**STATE OF CALIFORNIA
REGIONAL WATER QUALITY CONTROL BOARD
CENTRAL COAST REGION**

STAFF REPORT FOR REGULAR MEETING OF NOVEMBER 13, 2014

SUBJECT: Order No. R3-2014-0046, Revision of Waste Discharge Requirements for California Army National Guard - Camp Roberts Training Facility, San Luis Obispo and Monterey Counties

Figure 1 - Existing and Proposed Schematic

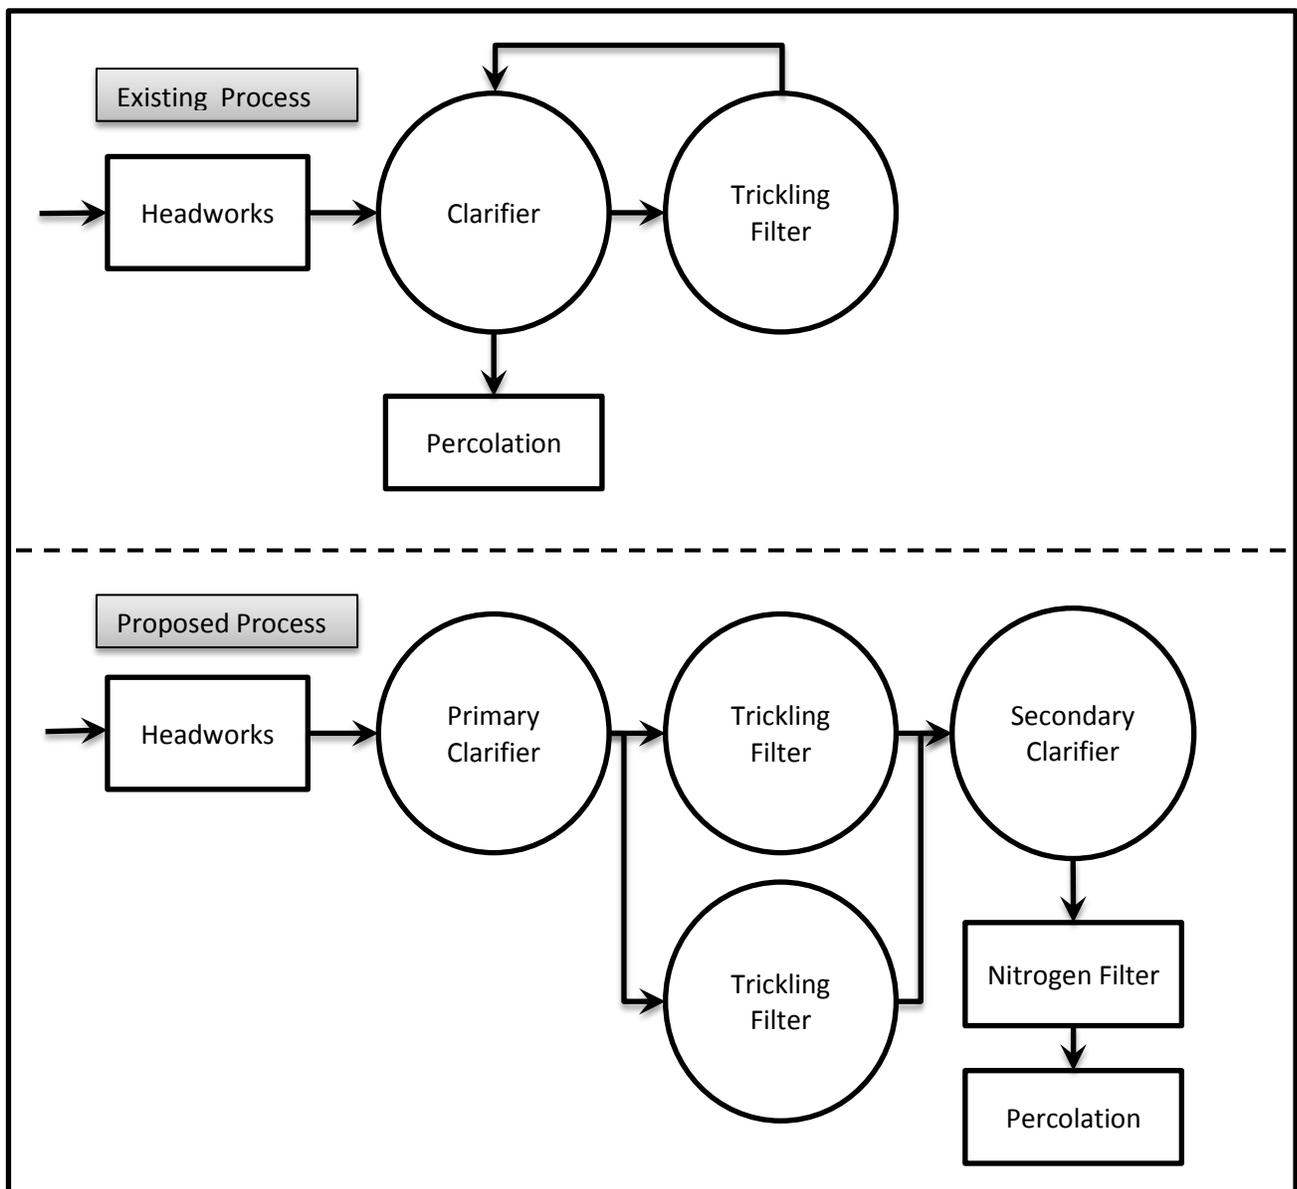
The improvements will refurbish an abandoned clarifier and trickling filter, as well as alter plumbing to achieve true secondary clarification. The upgrade to the existing Main Garrison wastewater treatment and discharge facilities is represented by the following schematic:

As shown and mentioned above, a key improvement is separation of primary and secondary clarification stages to eliminate discharge of partially treated wastewater and improve overall effluent quality with respect to BOD and suspended solids. Another key improvement is the addition of a denitrifying filter to reduce effluent nitrogen concentrations. The proposed first phase of installing denitrification treatment would provide nitrate treatment capacity for an average daily flow of 0.04 MGD. Additional filter capacity would be required in the future when the Camp Roberts population increases.
